1. Type of Well				-
Oil Well X Gas Well Other				8. Well Name and No.
2. Name of Operator				Jasper ARJ Federal #2
Yates Petroleum Corporation				9. API Well No.
3a. Address 3b. Phone No. (include area code)				1
105 South Fourth Street, Artesia, NM 88210		(505) 748-1471		10. Field and Pool, or Exploratory Area

4. Location of Well (Footage, Sec., T., R., M., or Survey Description)				Foor Ranch Precambrian
760' FNL & 2240' FEL				11. County or Parish, State
Section 25 T8S-R26E				Chaves County, NM
				Chaves County, Nivi

Typical 2,000 psi choke manifold assembly with at least these minimun features

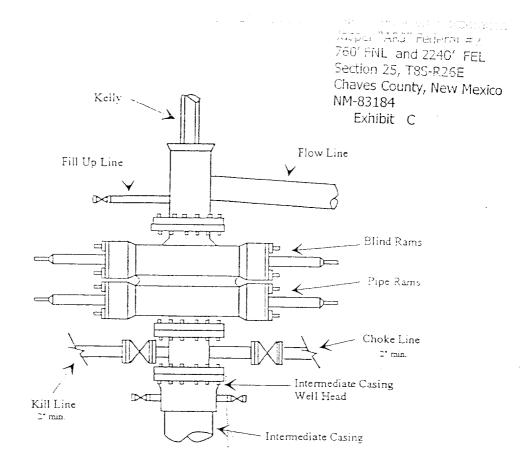
12. CHECK APPROPRIATE BOX(ES) TO INDICATE NATURE OF NOTICE, REPORT, OR OTHER DATA				
TYPE OF SUBMISSION	TYPE OF ACTION			
Notice of Intent	Acidize	Deepen Deepen	=	(Start/Resume) Water Shut-Off
Subsequent Report	Alter Casing	Fracture Treat	Reclamation	= ' '
Subsequent Report	Casing Repair  Change Plans	New Construction Plug and Abandon	Recomplete Temporarily	
Final Abandonment Notice	Convert to Injection	Plug Back	Water Disp	
If the proposal is to deepen directionally or recomplete horizontally, give subsurface locations and measured and true vertical depths of all pertinent markers and zones. Attach the Bond under which the work will be performed or provide the Bond No. on file with BLM/BIA. Required subsequent reports shall be filed within 30 days Following completion of the involved operations. If the operation results in a multiple completion or recompletion in a new interval, a Form 3160-4 shall be filed once. Testing has been completed. Final Abandonment Notices shall be filed only after all requirements, including reclamation, have been completed, and the operator has determined that the site is ready for final inspection.)  YPC respectfully requests permission to make the following changes to this well.  We would like to change the BOP working pressure from 3,000 psi to 2,000 psi.  We also request that a variance be granted to test the 2,000 psi system to 1,000 psi using the rig pump.  Further, we would like to change the 8 5/8" casing setting depth from 900' to 1,000'. The depth of 1,000' should result in a better casing seat.  2K BOP schematic is attached.
